North Campus Faculty Housing Phase II  
Project No. FM110407L/986315

**Addendum No. 6**

ADDENDUM NUMBER 6  
to the  
CONSTRUCTION DOCUMENTS

BUILDING 400A: SECTIONS 2

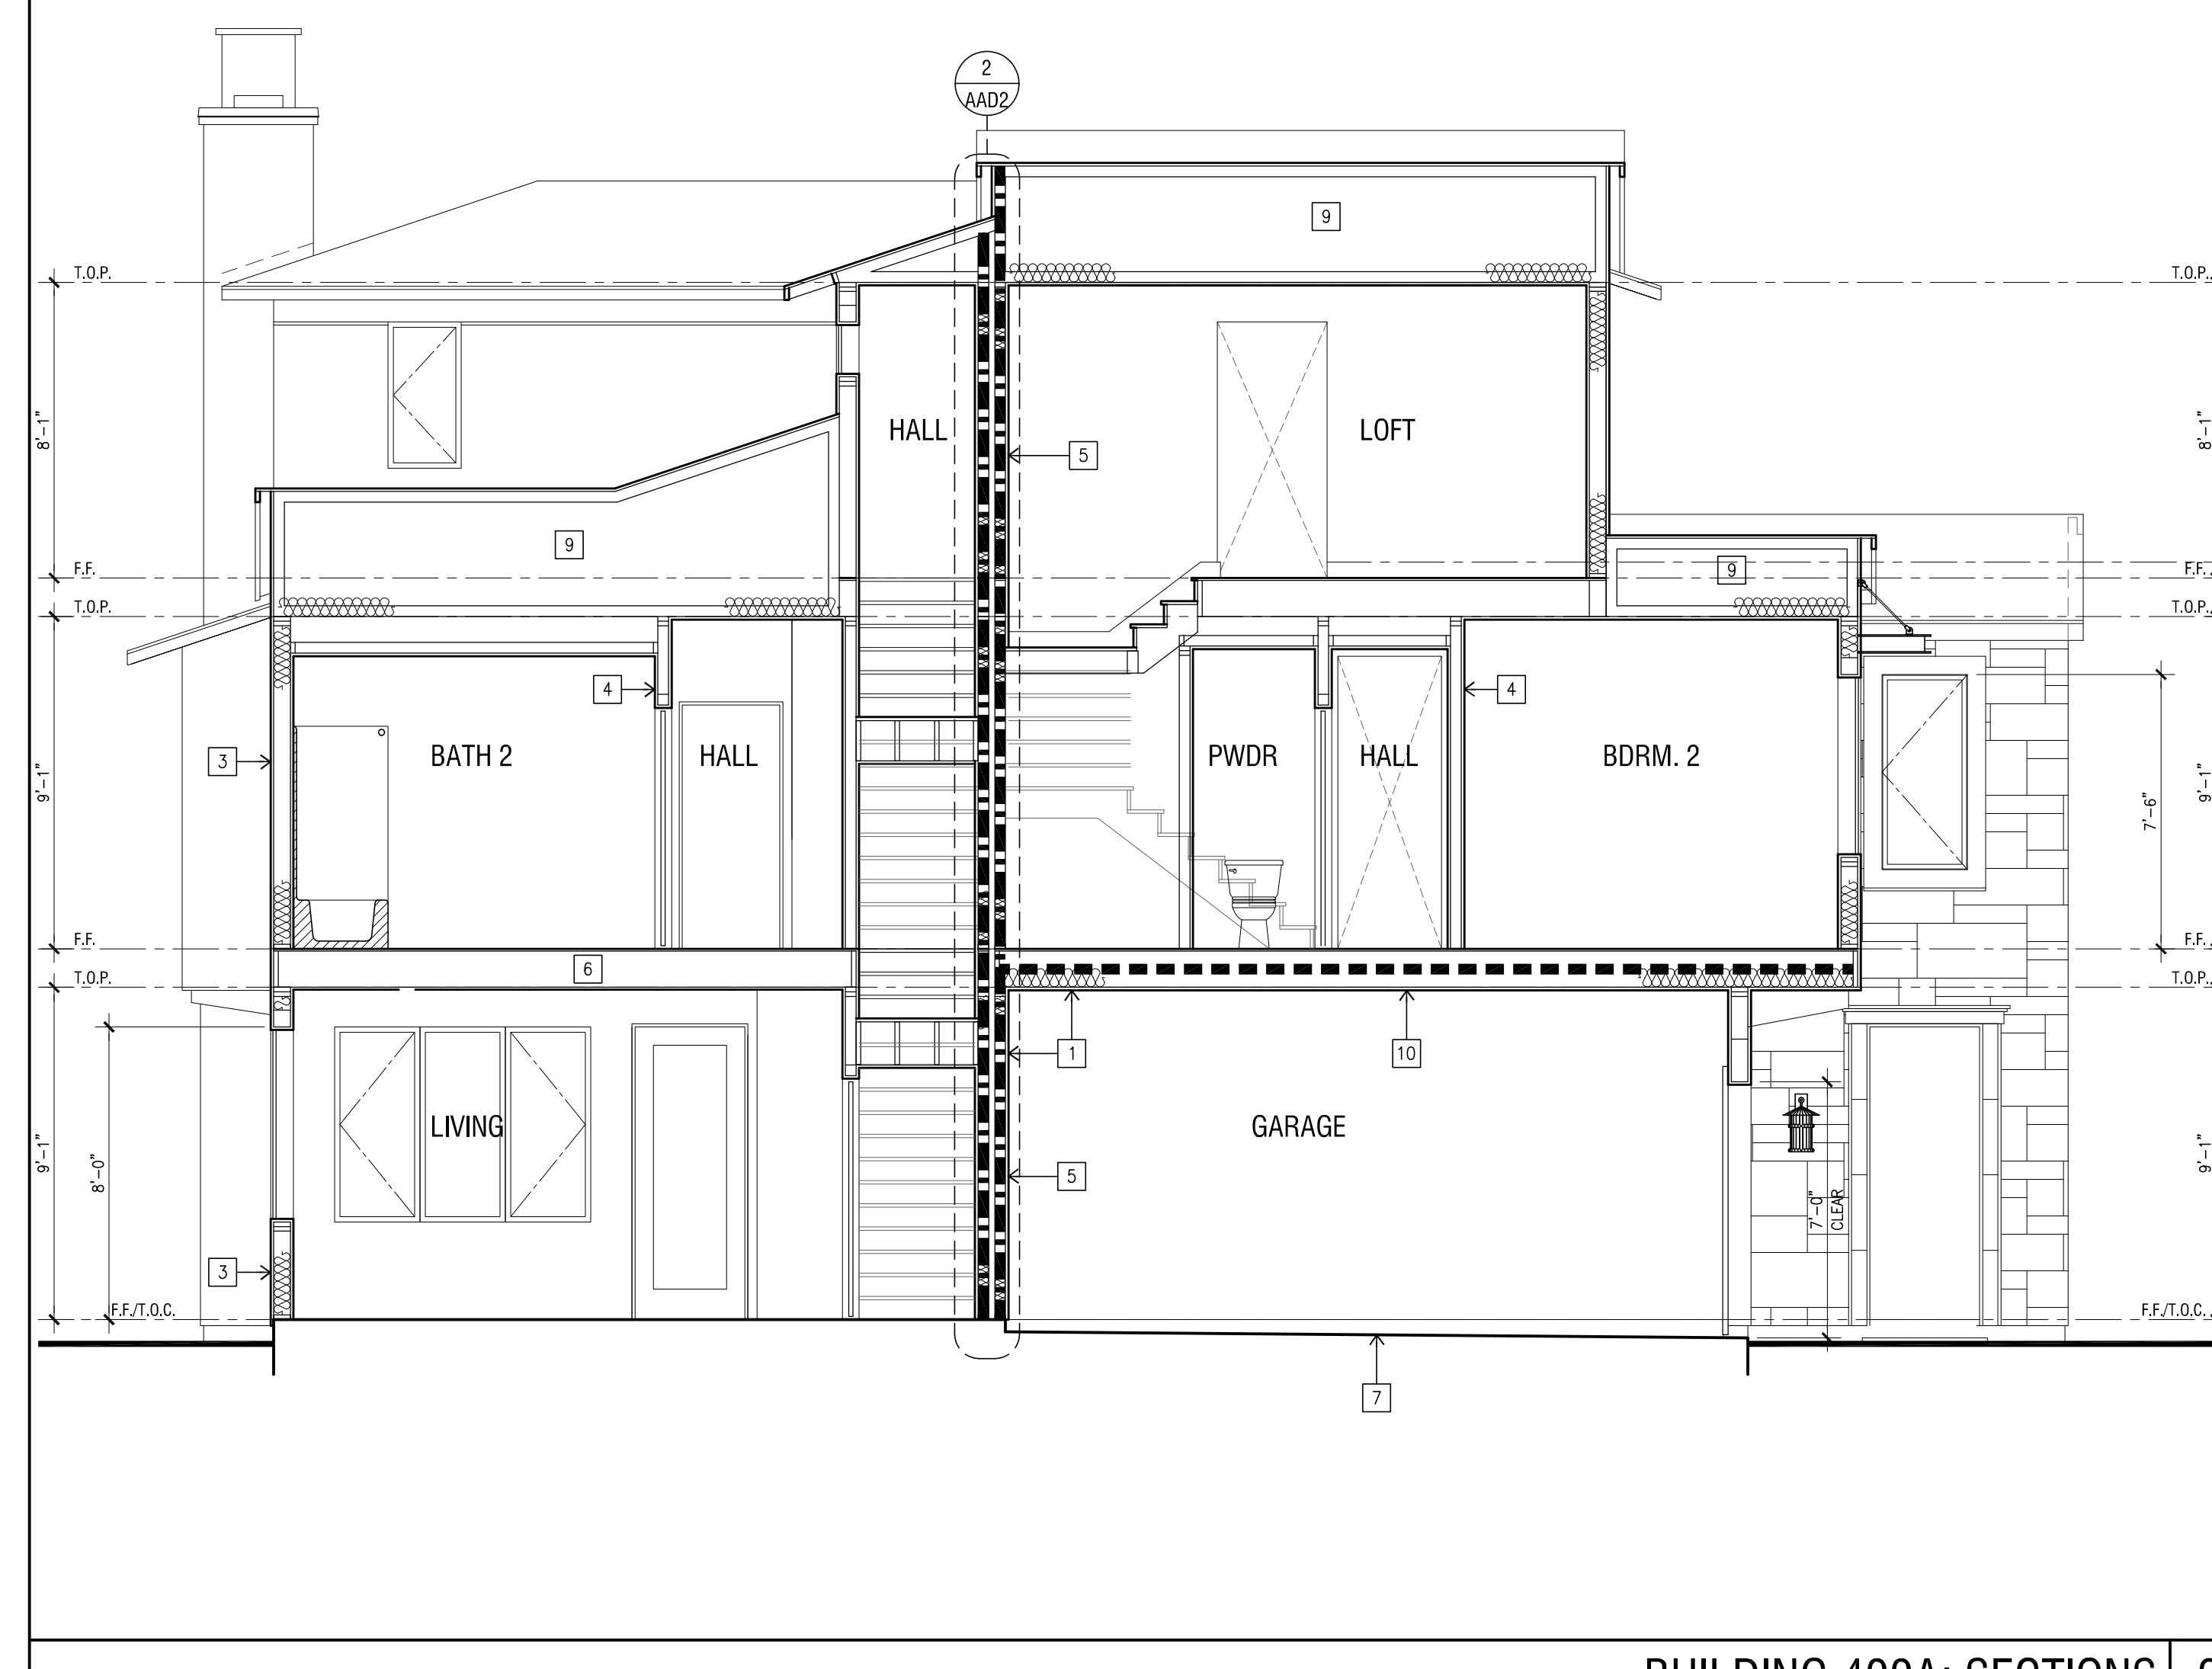
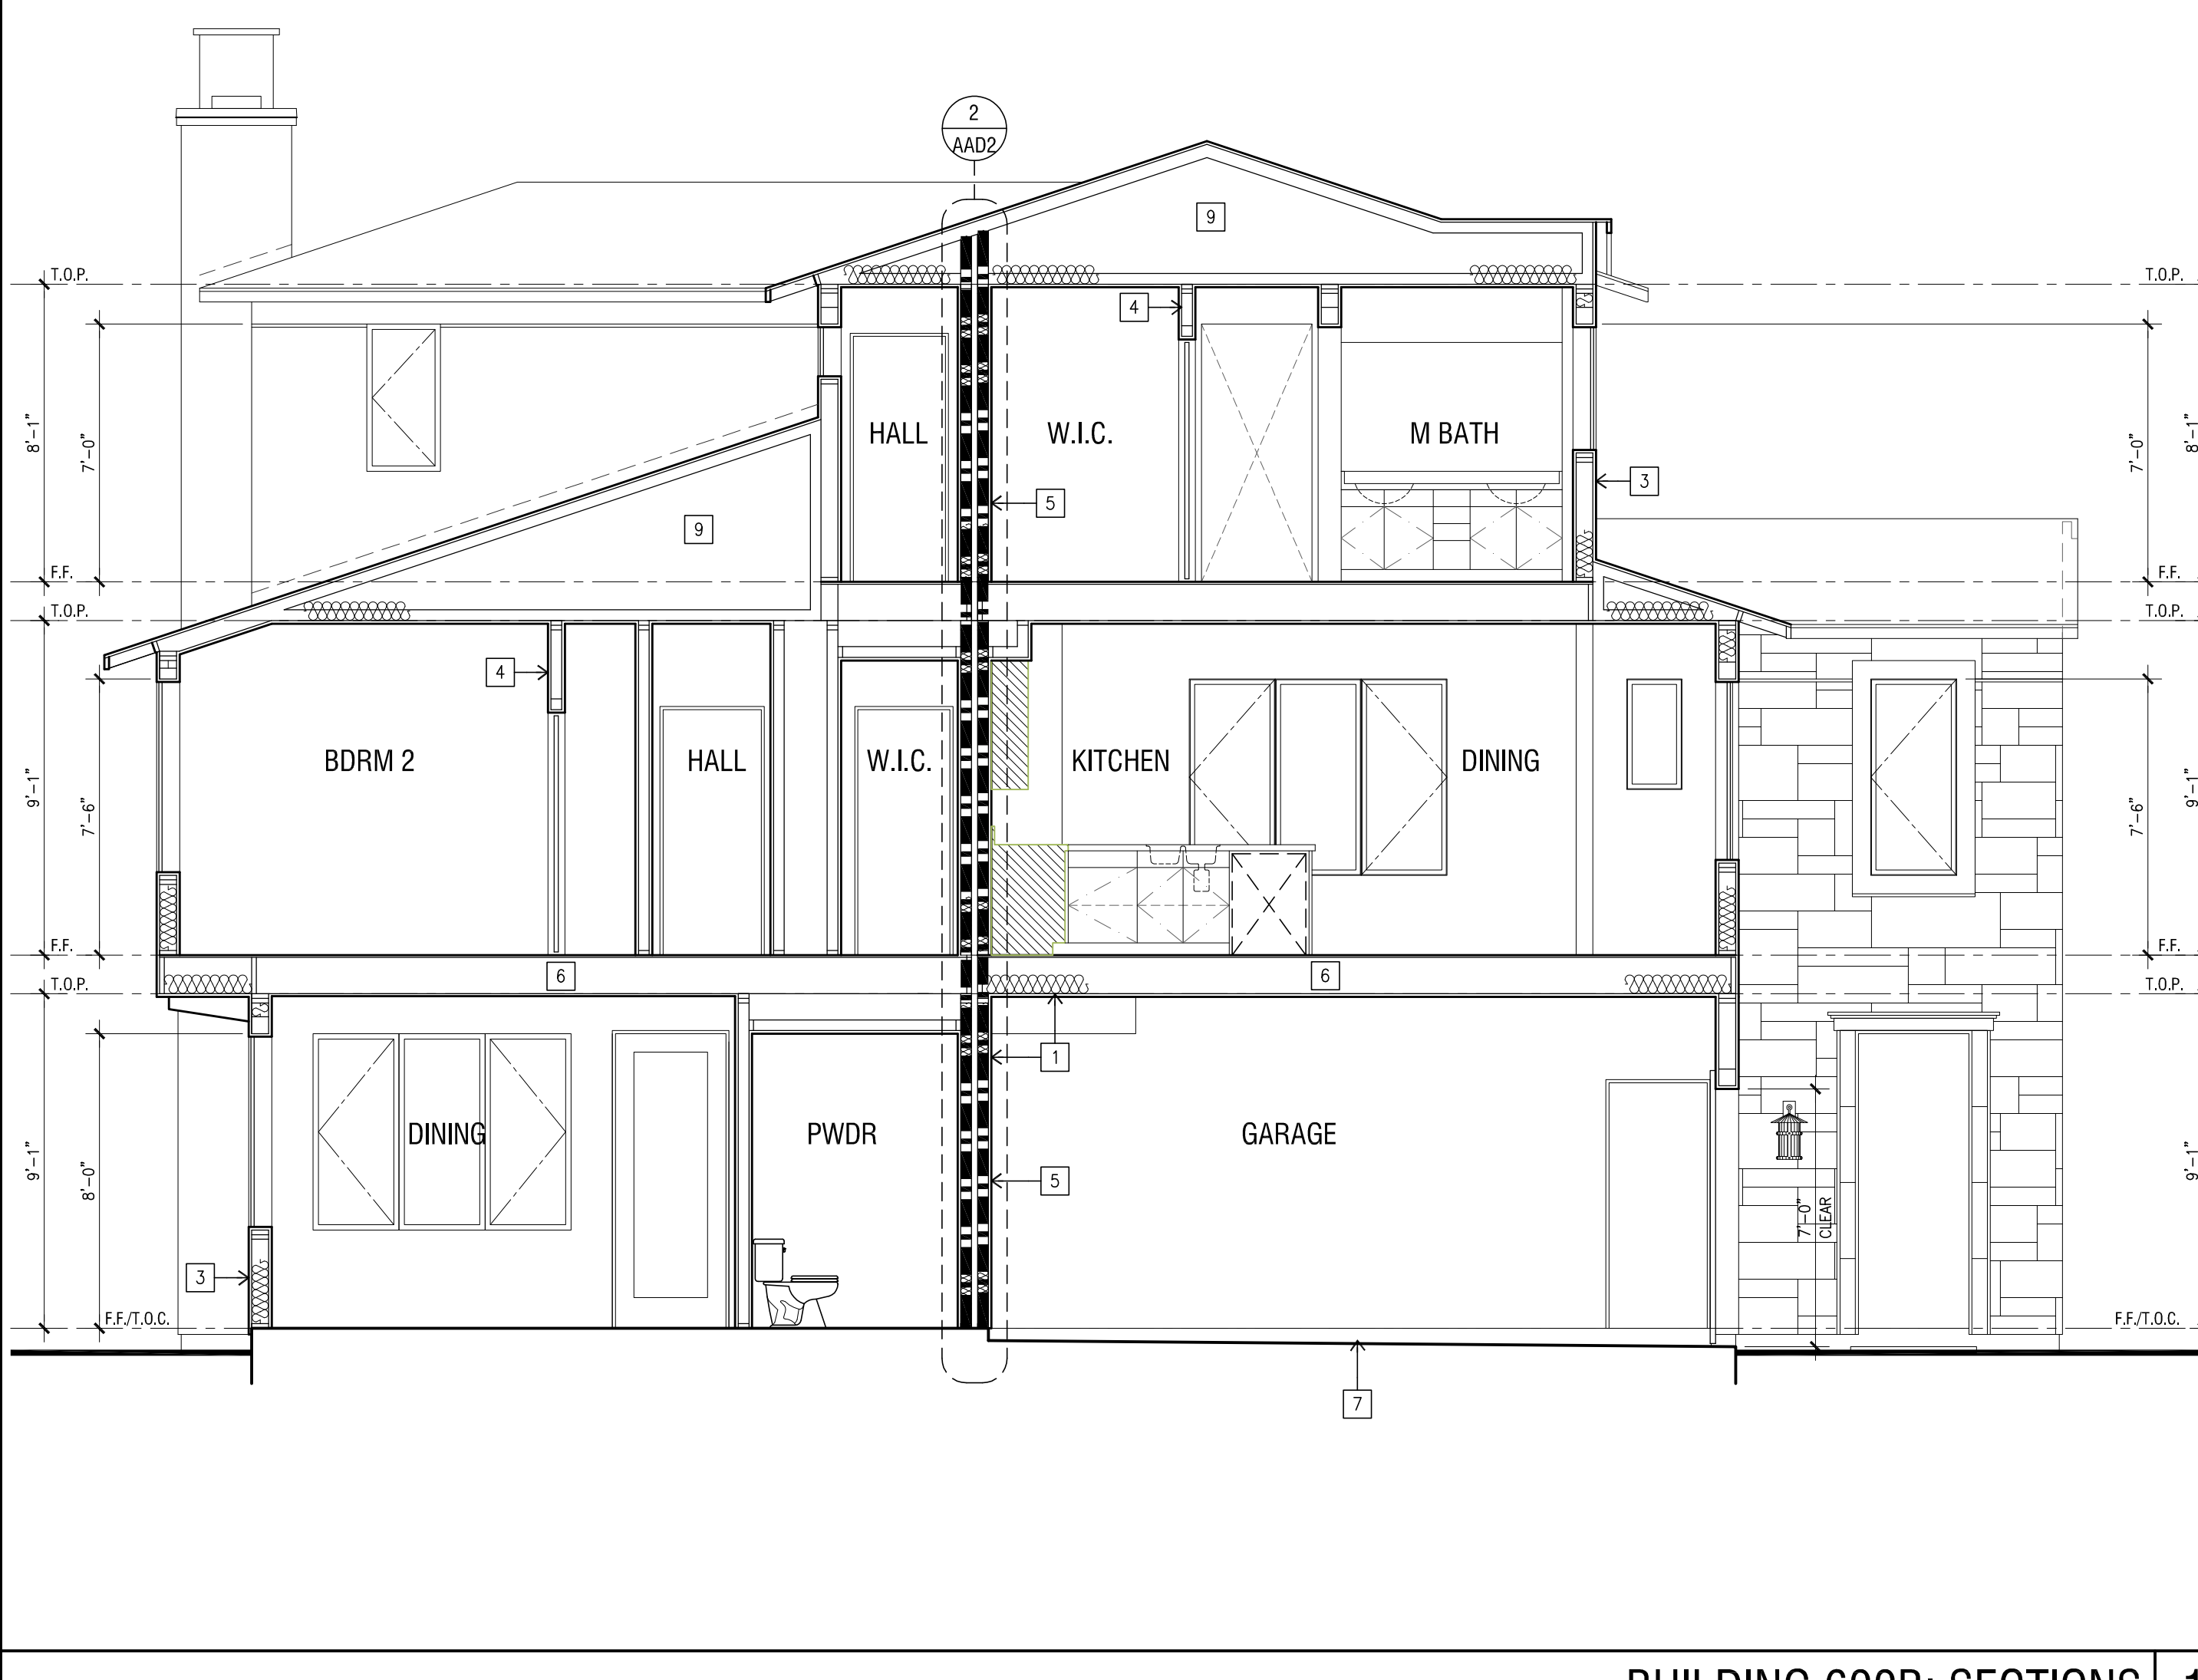
Sketch 5 of 8	Building 600A: Reverse: Sections
Sketch 6 of 8	Building 600B: Sections
Sketch 7 of 8	Building 700A: Sections
Sketch 8 of 8	Building 700A: Reverse: Sections
